## STAFF REPORT

### PLANNING COMMISSION PUBLIC HEARING

**FILE NO.:** DR-08-01/VAR-08-01/WAP-08-01

**REQUEST:** CLASS II DESIGN REVIEW, WATER RESOURCES  
AREA PERMIT, AND A CLASS II VARIANCE FOR  
AMOUNT OF DEVELOPMENT PROPOSED IN THE  
WATER RESOURCE AREA, FOR A 70-UNIT HOTEL AT  
2400-2450 WILLAMETTE FALLS DRIVE

## SITE PLAN

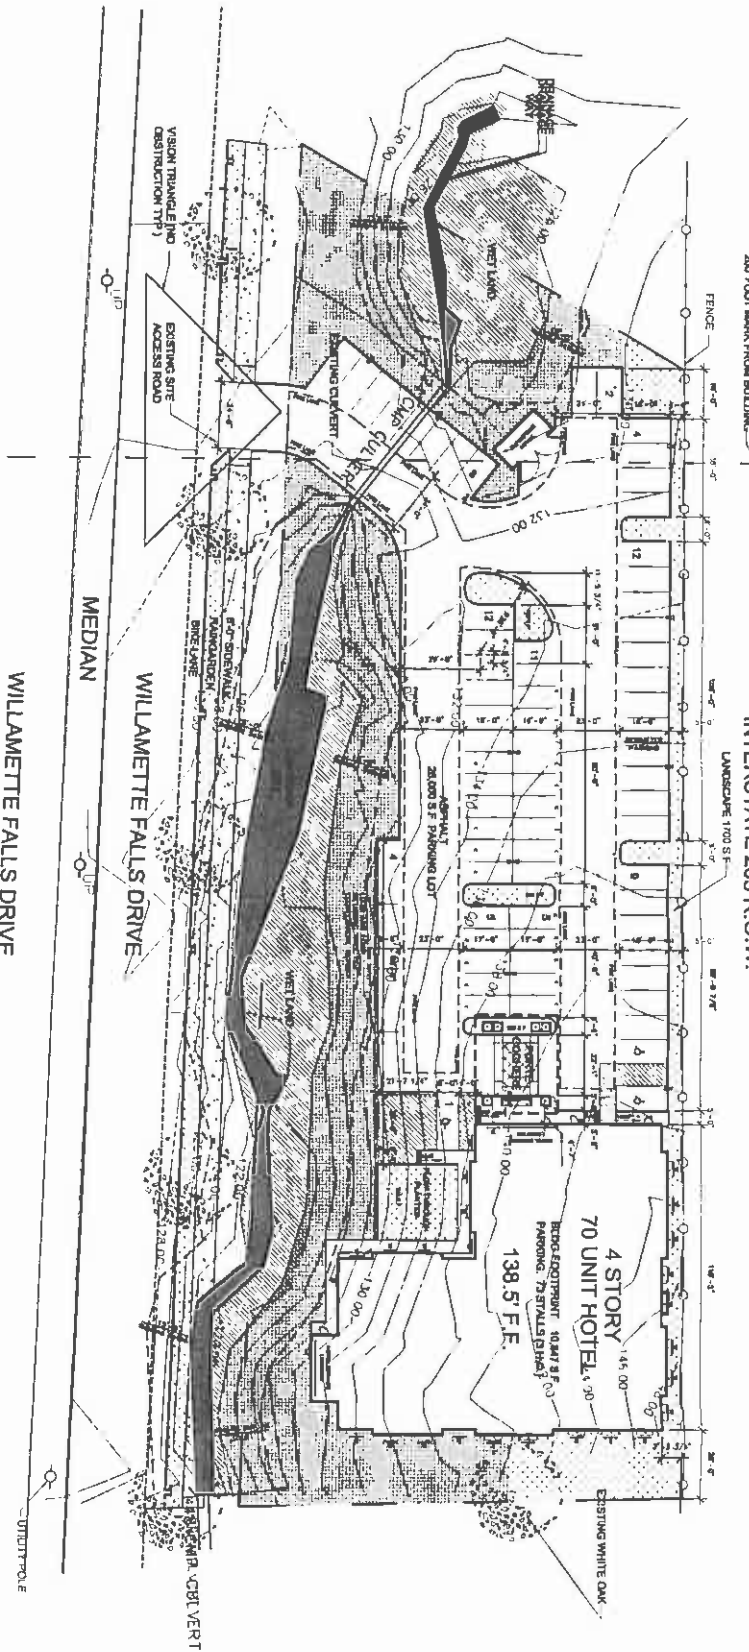
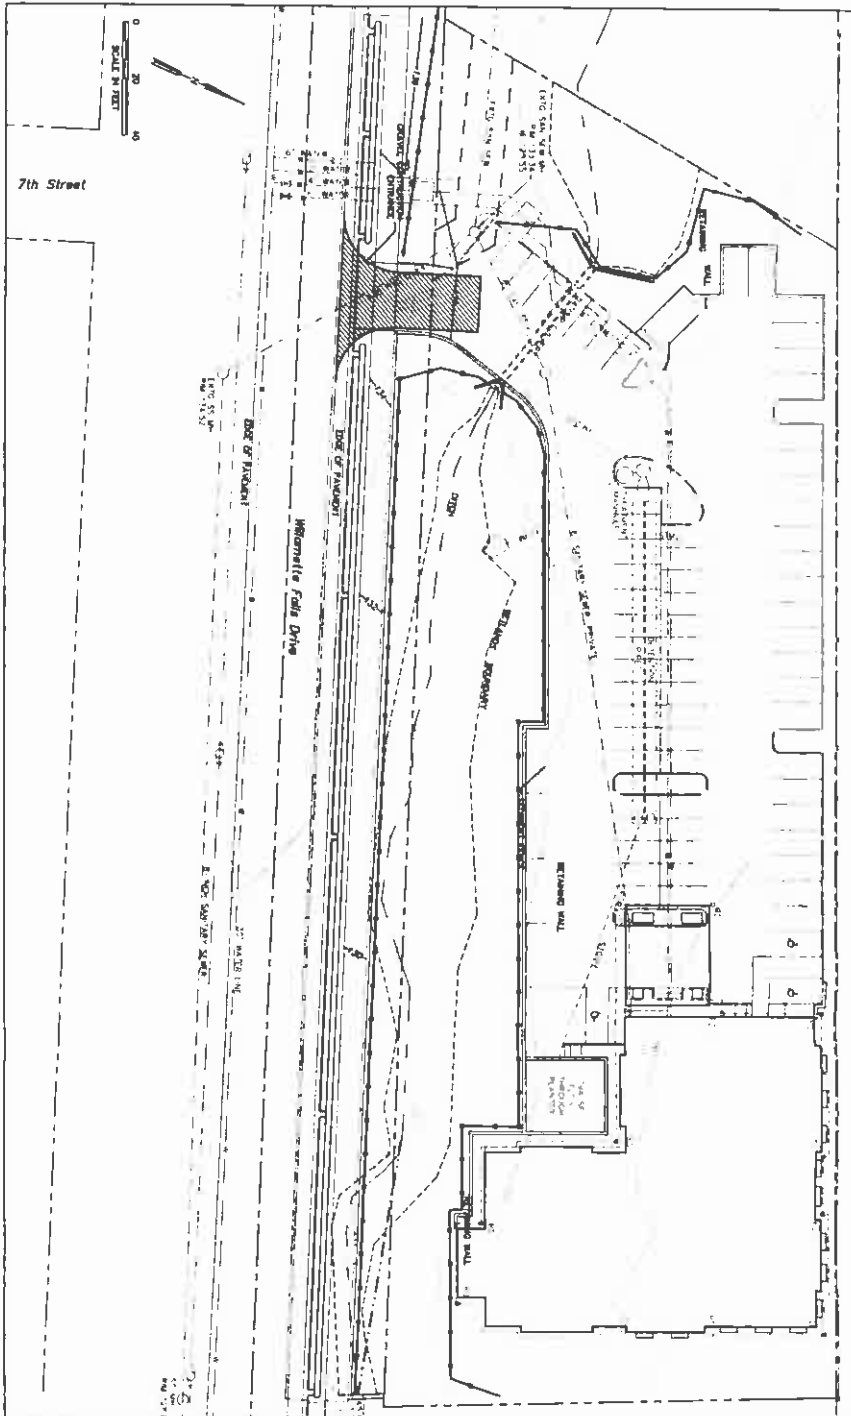
After reviewing the letter of November 11, 2008 from the applicant that is in response to Fire Plan review of October 29<sup>th</sup> there are still outstanding issues that need to be clarified. Until Tualatin Valley Fire & Rescue is able to determine that the equivalent degree of protection is being provided with the alternate means and methods (AMM), we can not endorse this project. Additionally, any alternate method of construction will need to be approved by the Building Official.

- ***The fire rating of the proposed fire partitions is not indicated.***
  - ***If there are 2 firewalls installed, draft stopping every 3,000 sf would not add any additional fire protection.***

- 11) **FIRE HYDRANT NUMBER AND DISTRIBUTION:** The minimum number and distribution of fire hydrants available to a building shall not be less than that listed in Appendix C, Table C 105.1. Provide site plan with locations of hydrants for approval.

In response to the letter from Tualatin Valley Fire & Rescue – South Division and the meeting on November 7<sup>th</sup>, attached is a revised site plan that further addresses the concerns of the fire department. We think that this is a viable site plan that not only addresses the Fire Department but all requirements that we are aware of to date. Below is the response to the letter dated October 29, 2008:

***Applicant Response:*** As discussed in the meeting on November 7<sup>th</sup> – Turnaround provided under porte cochere. In doing so, the porte cochere shall be constructed of non-combustible materials and rated 1-hr. The Porte Cochere is an independent structure not supported by the building. The Porte Cochere shall be a minimum of 15'-0" clear unobstructed height. The porte cochere shall be a minimum of 24'-0" wide (actually 30'-0" wide to allow for radius).

**Applicant Response:** No parking will be allowed in the fire apparatus access road. This areas is clearly marked on the site plan and the no parking will be labled on the ground and with signs where needed.

**Applicant Response:** *We request that hydrant locations be selected during the building permit phase.*
